<b>OFFICE OF ENVIRONMENTAL SUSTAINABILITY</b>	
<b>INSPECTOR'S REPORT ON AN APPLICATION FOR A CERTIFICATE OF AUTHORISATION FOR A CLOSED LANDFILL</b>			
<b>TO:</b>	Director		
<b>FROM:</b>	Ewa Babiarczyk, Inspector,	Environmental Licensing Programme	
<b>DATE:</b>	18 <sup>th</sup> May 2022		
<b>RE:</b>	Application by <b>Galway County Council</b> for a Certificate of Authorisation for a closed landfill at <b>Galway County Council Roads Depot, Tullyvoheen, Clifden, County Galway.</b> Certificate of Authorisation Register Number <b>H0176-01.</b>

## 1. Application details

**Figure 2: Site layout, extent of the deposited waste and groundwater (BH), leachate (LC), gas (BH & LC) monitoring locations**

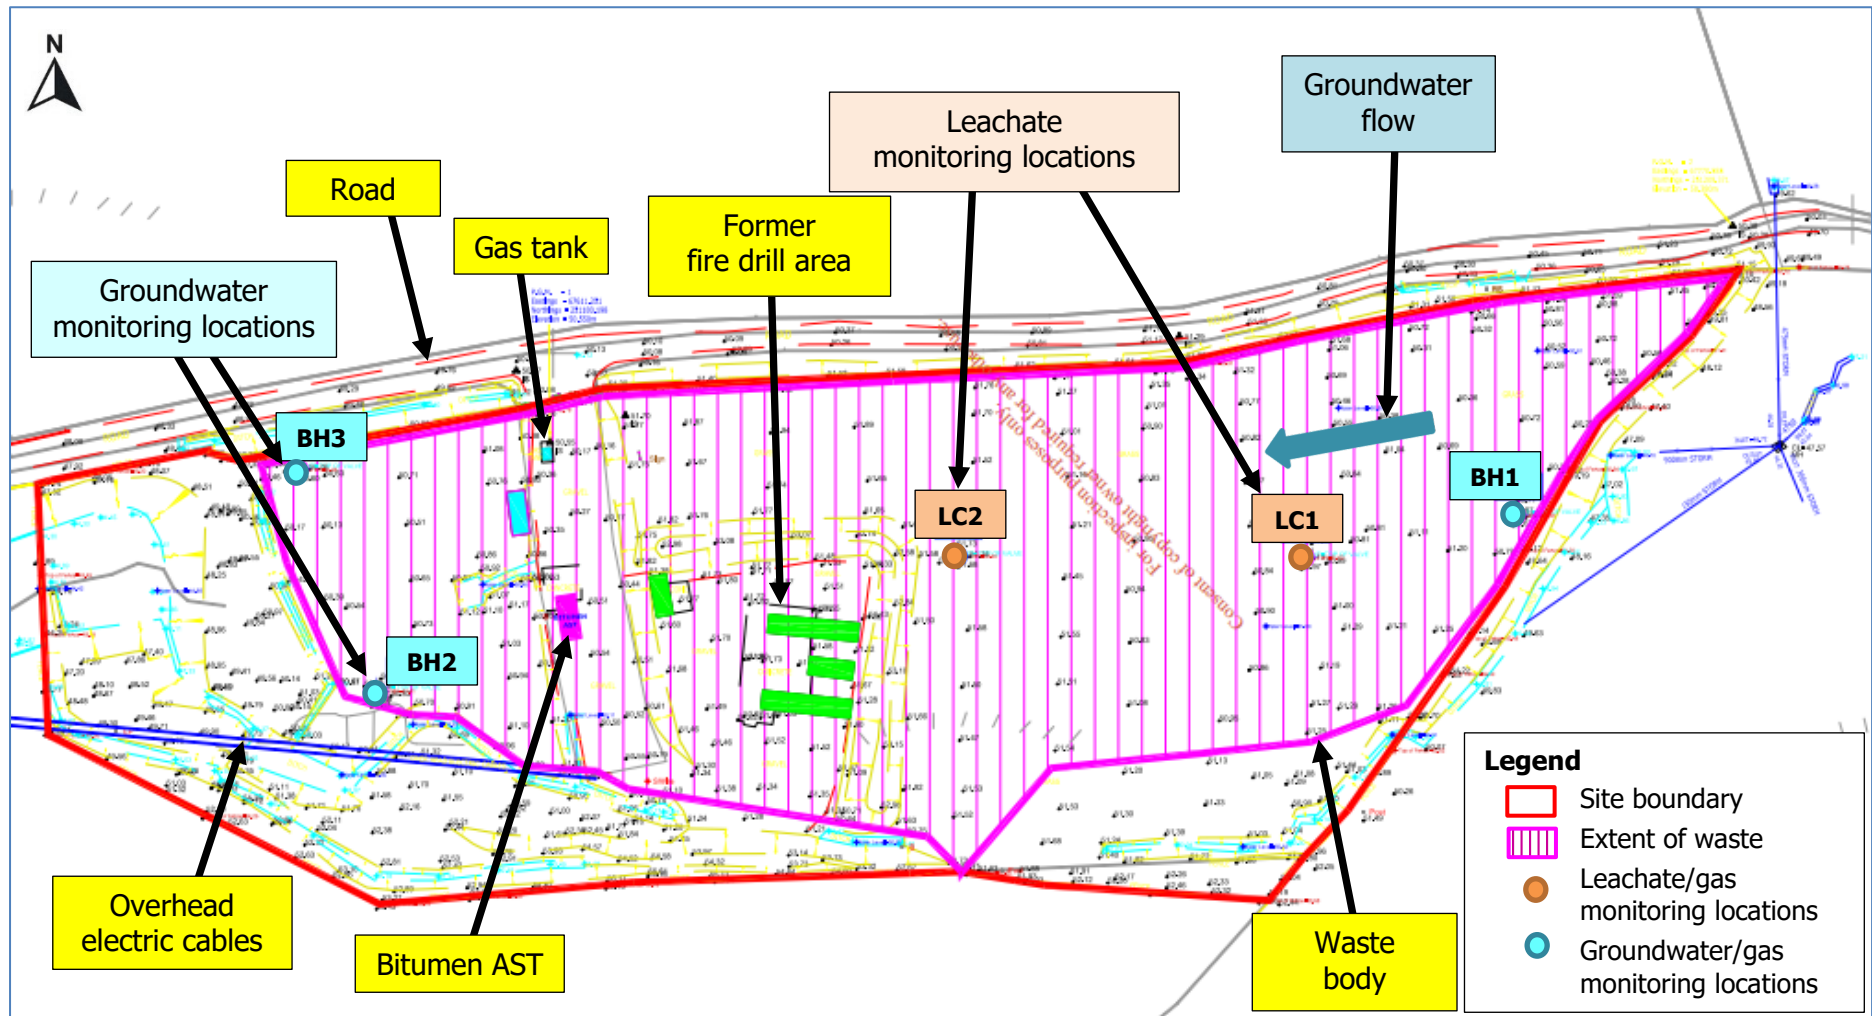
It is noted that, along the western and south-western site boundary, the site extends beyond the waste body, as shown in Figure 2. This area of the site is considered appropriate for installation of monitoring boreholes for monitoring of groundwater downgradient of the waste body. Accordingly, Condition 3.1(e) requires installation of at least two groundwater monitoring boreholes downgradient of the waste body. Condition 3.9(e) and Schedule A.4 require groundwater monitoring at the existing borehole BH1 and at the two additional boreholes required under Condition 3.1(e) on a quarterly basis. Schedule A.4 specifies the minimum parameters to be monitored. Also, due to the fact that the waste contains municipal waste, it is considered that monitoring for organic compounds in the groundwater is appropriate. Accordingly, Condition 3.9(f) requires an annual screening of groundwater for trace organic substances.

The monitoring results show that landfill gas is being generated within the waste body and may be migrating outside the waste body, as indicated by the presence of gas in the monitoring locations at the edge of the waste body BH1, BH2 and BH3. It is also noted that the trigger levels for monitoring emissions of methane and carbon dioxide outside the waste body of, respectively, 1% v/v or greater and 1.5% v/v or greater, as set out in the Agency Landfill Manuals - Landfill Monitoring, 2<sup>nd</sup> Edition, 2003, were exceeded in respect of methane in June 2021 at two locations at the edge of the waste body (1.6% at BH1 and 3.7% at BH3) and, at the same locations in respect of carbon dioxide, in June 2021 (8.8% at BH1 and 3.8% at BH3) and July 2021 (9.1% at BH1 and 6.1% at BH3). It is furthermore noted that the gas levels monitored at locations LC1, LC2, BH2 and BH3 in 2014 were significantly lower than the gas levels measured at these locations in 2021.

Additionally, Condition 3.8 requires a drawing showing the interpolated extent of the waste body, the area capped in accordance with Condition 3.1(b) and the gas vents installed in accordance with Condition 3.1(c).

**Figure 3.1: Surface water monitoring locations SW1 to SW3**

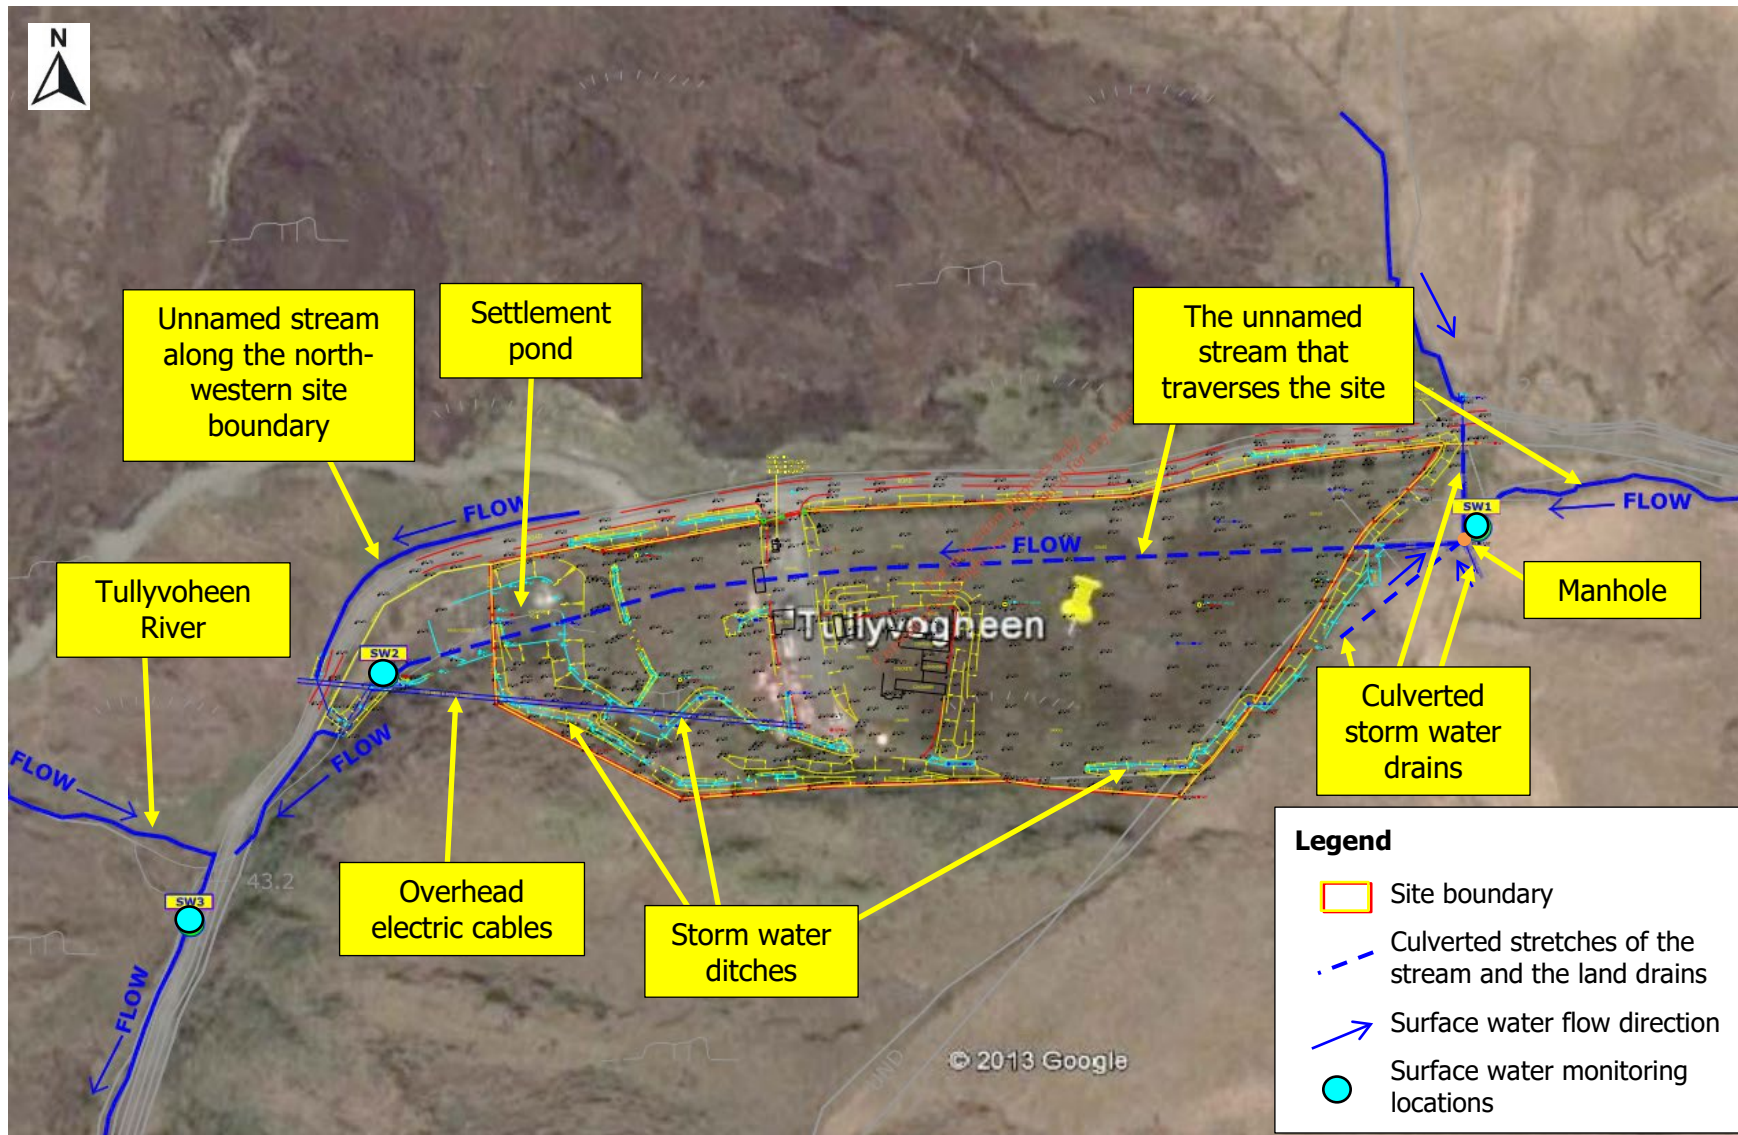
The applicant carried out surface water monitoring at three locations SW1, SW2 and SW3 on 29<sup>th</sup> January 2014, as shown in Figure 3.1 and at seven locations SW1 to SW7 on 30<sup>th</sup> September 2019, as shown in Figure 3.2. The table below states the location of each monitoring point.

The monitoring results show that concentrations for total ammonia, copper, chromium, lead and zinc exceeded their environmental quality standards (EQSs) set out in European Communities Environmental Objectives (Surface Water) Regulations 2009, as amended, downstream of the landfill. The monitoring results also show that downstream concentrations of iron, manganese, faecal coliforms and total coliforms exceeded their limits set out in European Union (Drinking Water) Regulations 2014, as amended. The fact that the concentrations of a number of parameters at the downstream monitoring locations exceed the concentrations at the upstream location (ammonia, copper, iron, manganese, lead, nickel, zinc, total coliforms and faecal coliforms), indicates that the landfill leachate is having an impact on the downstream surface water quality. It is noted that other sources apart from the landfill may also be impacting results as MRP, chromium, iron, manganese and coliforms also exceed their relevant EQSs/limits at the upstream monitoring location SW1. It is further noted that it cannot be determined whether the actual concentrations for cyanide and mercury, were within the relevant standards as the limit of detection for the monitoring methods utilised were above the EQS.

Condition 3.9(d) and Schedule A.3 require quarterly monitoring of the unnamed stream that traverses the site at the upstream monitoring location SW1 and the downstream monitoring locations SW2, SW3 and SW4. In addition, Condition 3.9(g) requires that the sensitivity of the monitoring methods utilised shall have an appropriate limit of detection to allow for comparison of pollutant concentrations against the relevant standard reference values.

**Figure 3.2: Surface water monitoring locations SW1 to SW7 and Invertebrate kick sampling locations**

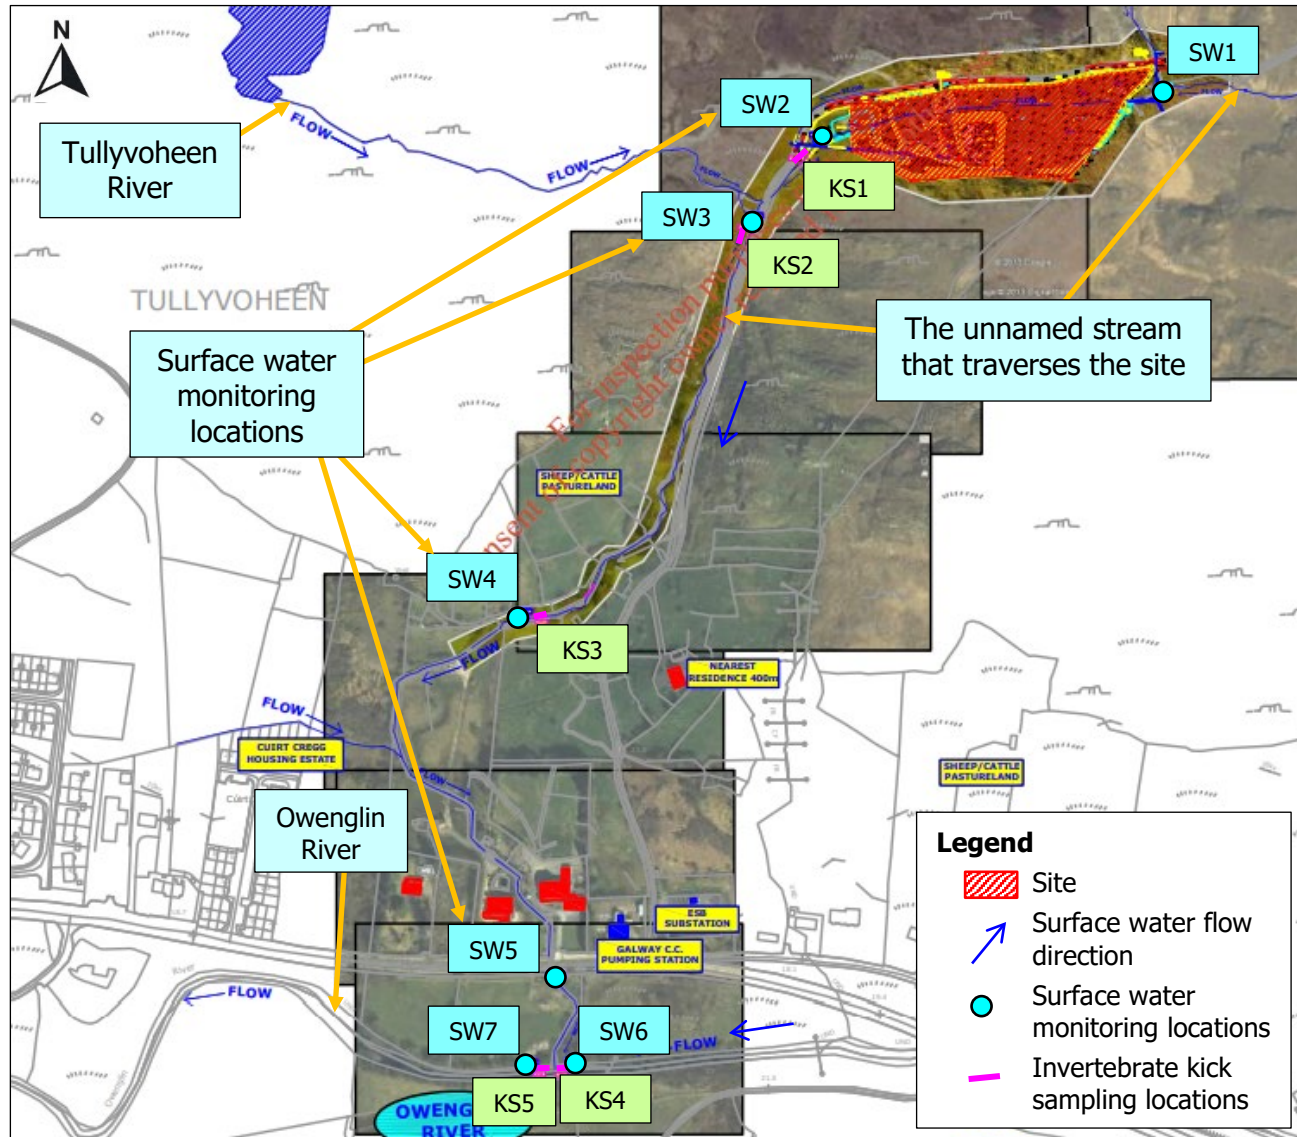
It is noted that monitoring locations SW4, SW5, SW6 and SW7 are

located at significant distances from the landfill. Due to the fact that groundwater beneath the site flows in a westerly direction, as shown in Figures 2 and 5, it is considered that monitoring results from locations SW1, SW2, SW3 and SW4 on the stream are representative of any potential impact from the landfill on surface water quality. Accordingly, the table below shows the maximum parameter concentrations recorded at surface water monitoring locations SW1, SW2, SW3 and SW4 from the monitoring event on 30<sup>th</sup> September 2019.

Invertebrate kick sampling was carried out at five locations KS1 to KS5 on the 28<sup>th</sup> September 2019, as shown in Figure 3.2. The below table lists the monitoring locations and Q value assigned to each location sampling result.

Condition 3.11 requires invertebrate kick sampling at the existing locations KS1 to KS5 and an additional location upstream of the landfill within six months of the completion of the remediation measures.
